ITEM NO:DPG 02FILE NO:100671.2016SUBJECT:Second Council Report noting Public Exhibition and Endorsement of Miller
Town Centre Master Plan

DPG 02	Second Council Report noting Public Exhibtion and Endorsment of Miller Town Centre Master Plan
Strategic Direction	Liveable Safe City Deliver an efficient planning system which embraces sustainable urban renewal and development
Key Policy	Urban Development Plans
File Ref	100671.2016
Report By	Murray Wilson - Senior Strategic Planner
Approved By	Toni Averay - Director Planning & Growth

Figure 1 – Extract Draft Miller Town Centre Master Plan

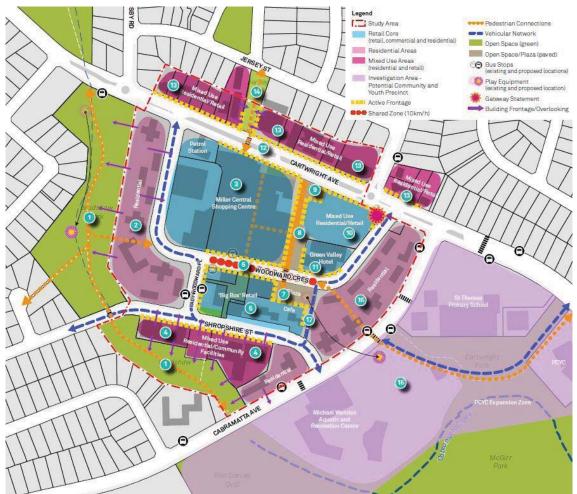
Figure 1 (below) represents the officer's preferred option. The preferred scenario is a hybrid of the four scenarios outlined above. There is a discrepancy between the preferred scenario and the possible zoning map as shown in Figure 32 of the draft Master Plan.

To be completely clear, it is noted that it is not planned to change the majority of the existing R4 zone on the eastern and western edges of the town centre to B2. It is only proposed to investigate rezoning land to the north of Cartwright Avenue and to the south of Woodward Crescent as depicted in the preferred scenario.

• The Miller Senior Citizens Centre is not shown in the Preferred Scenario;

Comment: The draft Master Plan did not include the Miller Senior Citizens Centre in the Preferred Scenario. This is to be corrected in the Master Plan. To clarify, the draft Master Plan does not propose the closure any community service as part of this process.

- 9. Include the Miller Senior Citizens Centre (adjacent to Bradshaw Park) in the preferred scenario; and
- 10. Correct minor grammatical and spelling errors (as required).
